City of Stanwood

Subject: Water Availability

Subject: Residential Treatment Facility Property - 22 102230 CUP

Water Availability Evaluation

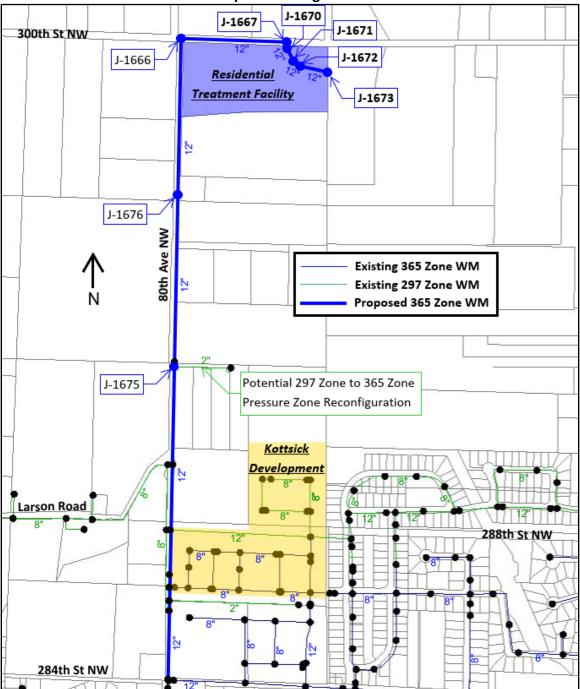
The proposed Development's location and assumed connection point to existing water main are shown on **Figure 1**. The Development is assumed to connect to the existing 12-inch-diameter water main at the intersection of 284th Street NW and 80th Avenue NW. As shown in **Figure 1**, the water main associated with the proposed Kottsick Development (approximately located north of 286th Place NW, between 80th Avenue NW and 75th Drive NW) was included in the model but has not yet been constructed. However, this water main was not modeled as connected to the proposed new water main at the intersection of 286th Street NW and 80th Avenue NW for the purposes of these analyses because the Kottsick Development has not been constructed.

Figure 1 depicts the layout of the Development's proposed 12-inch-diameter water main, and **Table 5** presents the results of the pressure and fire flow availability analyses.

Another consideration for this Development is to reconnect the 2-inch water main that connects to an existing 6-inch-diameter 297 Zone water main along 80th Avenue NW, north of Larson Road, to the proposed 12-inch-diameter 365 Zone water main. This location is called out on **Figure 1**. Performing this pressure zone conversion would allow the City to abandon approximately 800 feet of parallel 6-inch main. Under existing conditions, with service provided from the 297 Zone, pressures at the termination of the 2-inch water main are approximately 48 psi during PHD conditions. Reconnecting this main to the 365 Zone would cause pressures to increase to approximately 79 psi during PHD conditions. If the City desires to perform this pressure zone reconfiguration, it may need to consider individual pressure reducing valves to maintain service pressures under 80 psi. The City also should consider water quality concerns associated with dead-end water main should it choose to connect the 2-inch main to the proposed 12-inch main.

Water system capacity was evaluated for the proposed Development. The City's existing water system has sufficient supply, water rights, storage, and transmission capacity for the proposed Development demand, and sufficient distribution system capacity for the proposed Development fire flow. The water main configuration and diameters identified will provide a minimum available fire flow of approximately 1,890 gpm to the Development. It should be noted that the Development's water main plan indicates approximately 6,600 feet of dead-end water main. The City should consider water quality concerns associated with dead-end water main should this Development be constructed.
